**Block 6 - Hotel**

## Proximity of buildings - street hierarchy

Proposed section through new roof to bottling building - demonstrating sight lines from streetscape

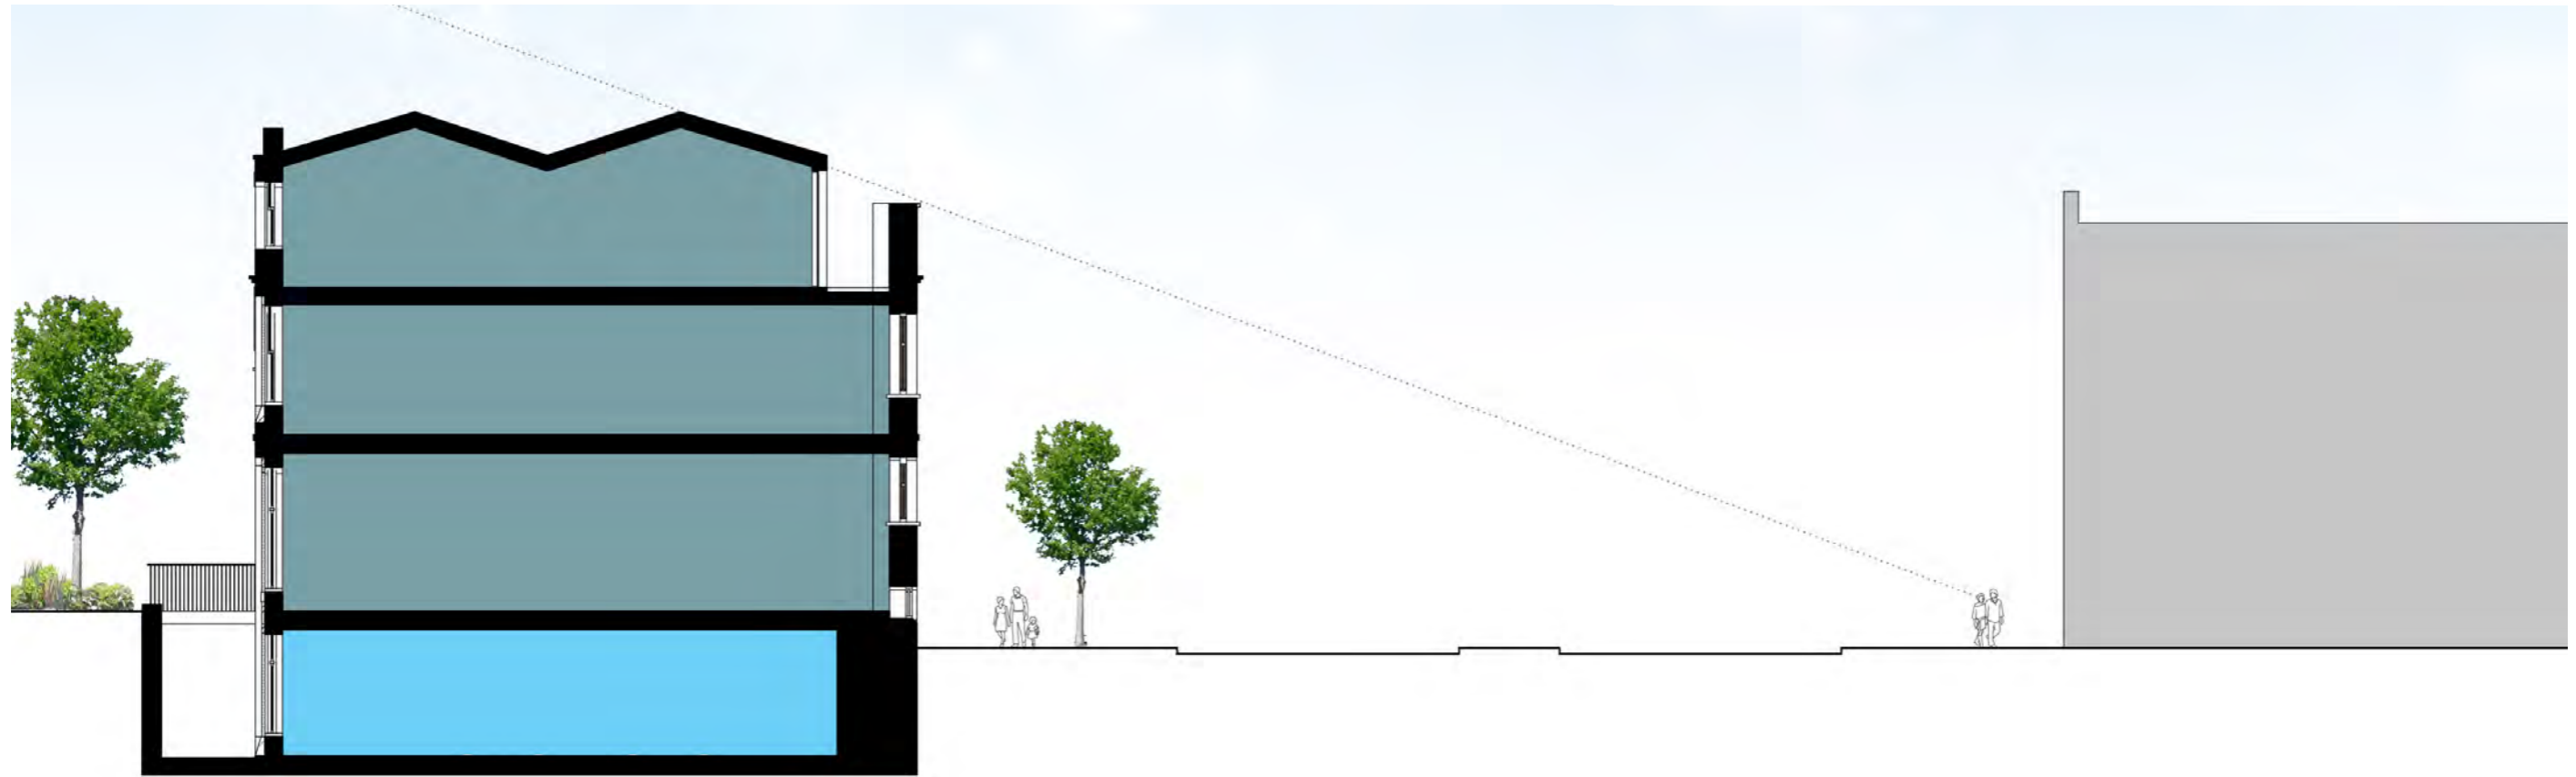
4. The roof behind the remainder of the south façade – a metal clad roof as shown is not appropriate. Amend to reflect comments.

We disagree that the (set back) metal roof to the proposed new office accommodation is inappropriate. This portion of the roof will be separated from the roof of the hotel by a brick gable/flank wall and therefore should not be considered part of the same roof element. Historically, the two roofs were built to different pitches and forms at different times (the former hotel in the late 19th century and the bottling building in 1869).

The massing of this roof element has been carefully designed so that it will be concealed from view from the streetscape. In order to achieve this, a shallow roof pitch is proposed (this 18 degree pitch is difficult to achieve in slate). The contemporary zinc cladding that is proposed offers the opportunity for continuity of both façade and roof materials – we believe this is a more resolved and comprehensive approach to the design of this modern intervention.

It is for these reasons that we believe the more contemporary appearance of the shallow pitched metal roof will not be detrimental to the streetscape.

Revised east elevation of Hotel

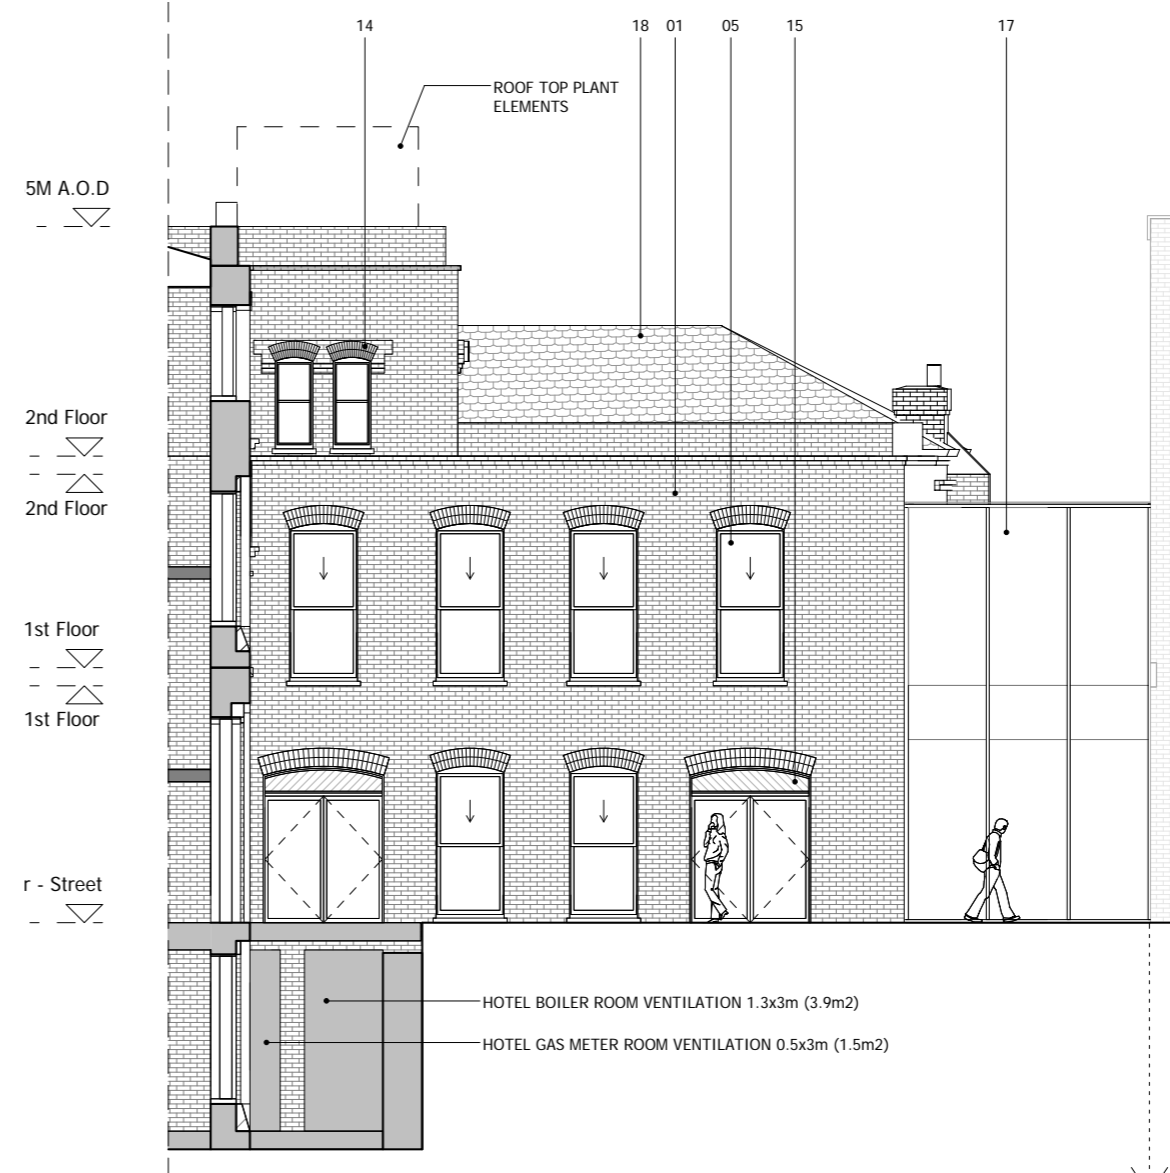
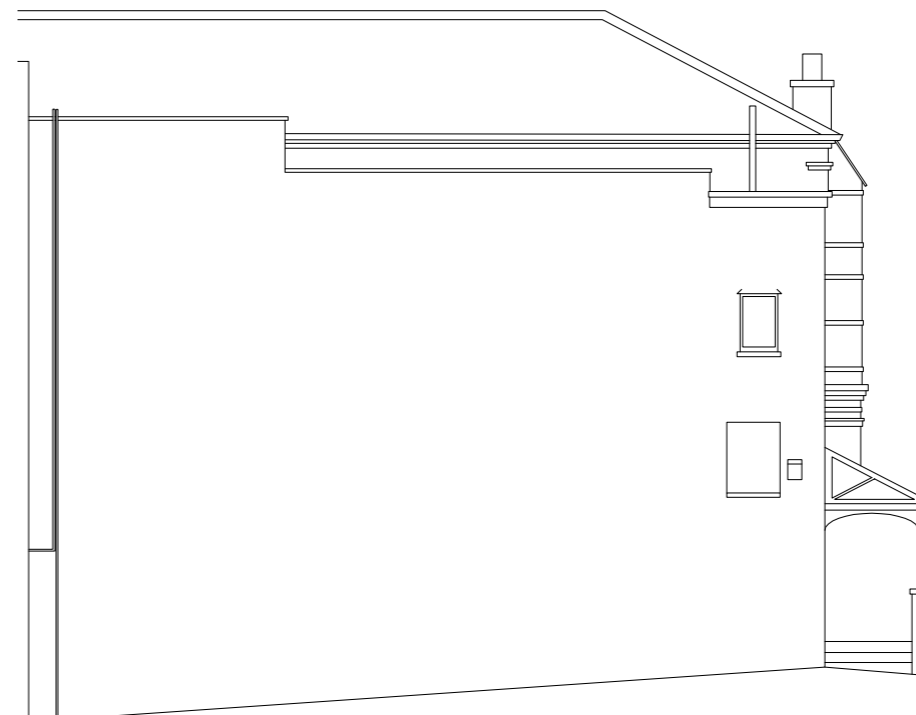
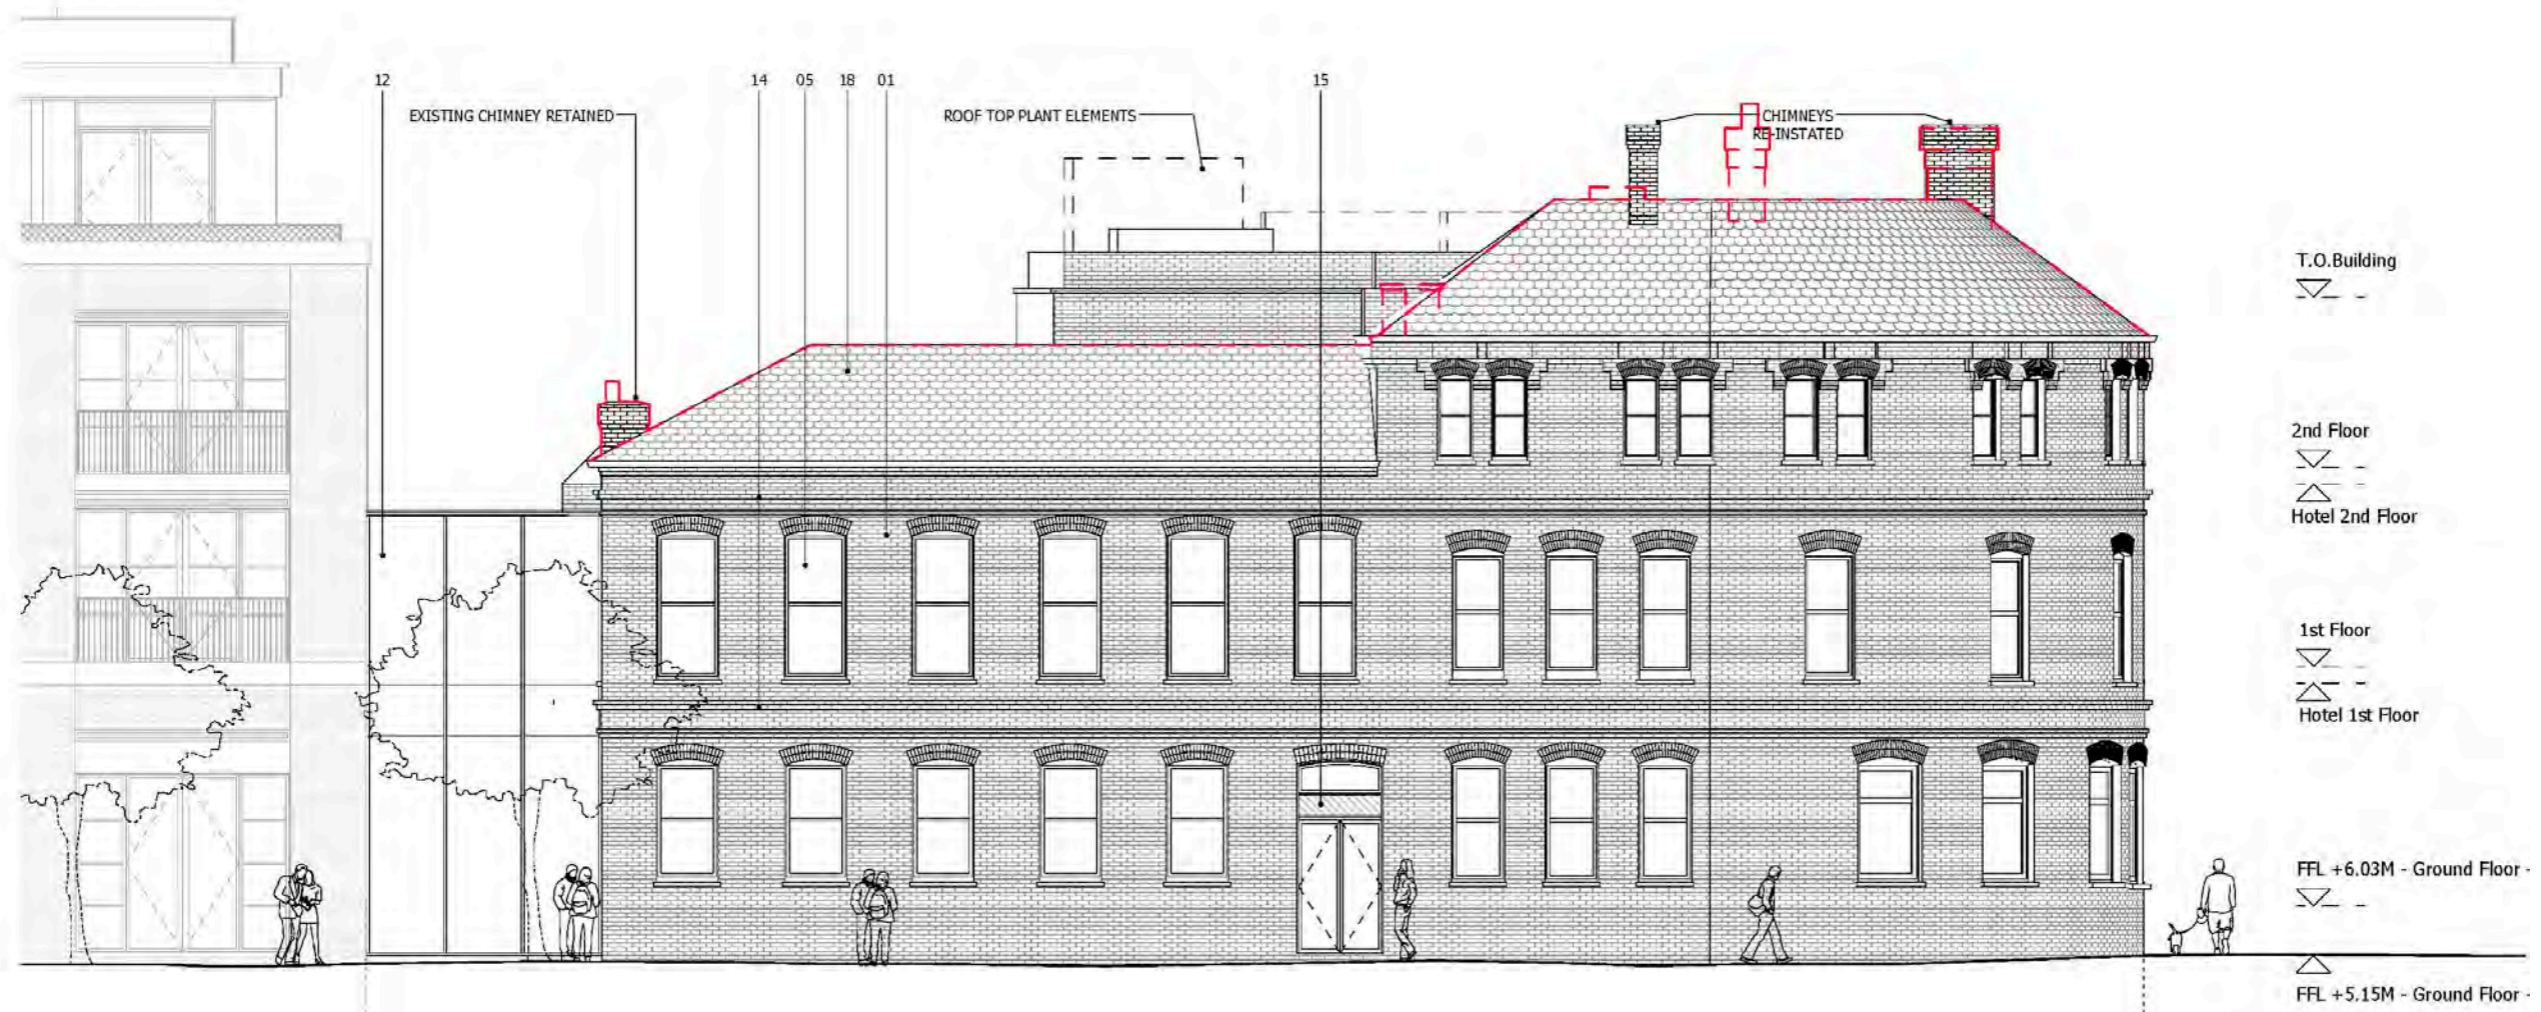
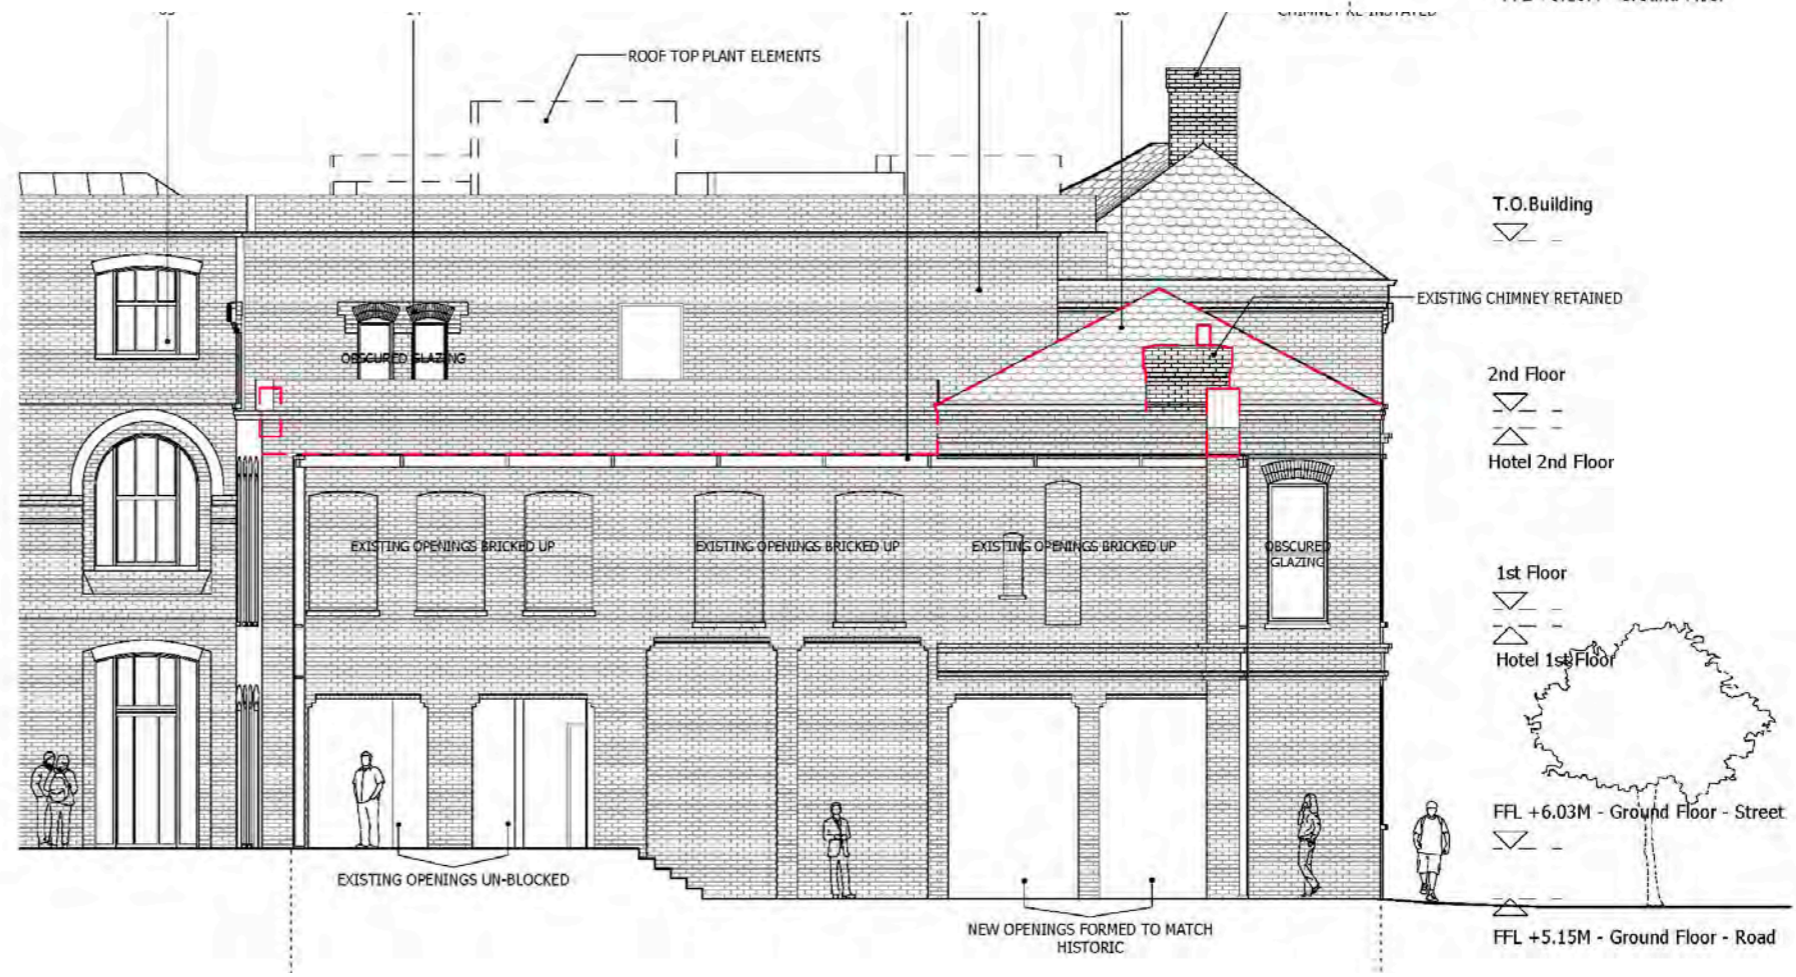
1. North façade of hotel – This building is a BTM in a prominent position. Facades are clearly visible from the public realm and the building forms an important part of the character of this part of the conservation area. The loss of all but the west/south façade represents substantial demolition and harm to BTM with lack of justification. Provide justification for substantial demolition. Must retain front and side facades, the roofline and chimney stacks.

- The chimneys are an important visual element of the hotel roofscape and should be retained for the corner landmark hotel. They are shown in the D+A statement vol2 as retained (p56), but shown removed in the planning application drawings – eg in D+A Statement vol5 – there are also some differences of fenestration. Removal of slate roof and chimneys are unacceptable. This would be damaging to the character of the BTM, architectural integrity and historic interest. The chimneys are an important part of the overall composition of the hotel roofline. The Heritage statement does not cover this issue. Retain chimneys and clarify differences in fenestration. The heritage statement does not cover this issue.

- Confusion over the roof materials of the hotel. Metal roof is shown on the application drawings, which is completely unacceptable, damaging to the character of the BTM, architectural integrity and historic interest – the hotel roof is in a pivotal position. However, the D+A S Vol 2 says ‘... slate roof to be reinstated’. Slate roof should be proposed/ reinstated.

We disagree that the North façade should be retained as opposed to demolished. The existing North façade meets an existing ground level which sits ???mm lower than the proposed new 'Bottleworks Square'. This new level is required due to flood level constraints (the level has been established in order to provide accessible routes that mediate between the existing streetscape and highest levels of flood defence). It is also proposed that a new (deepened) basement level is provided beneath the existing hotel. The combination of these factors make it an unviable solution to retain the north façade as part of the proposal for the hotel.

Drawings have been revised to show re-instatement of chimneys (in slightly different positions that co-ordinate with the structure of the building below). It is not possible to retain the existing chimneys because the existing basement is proposed to be deepened.

The drawings have been revised to show the replacement roof material as slate.
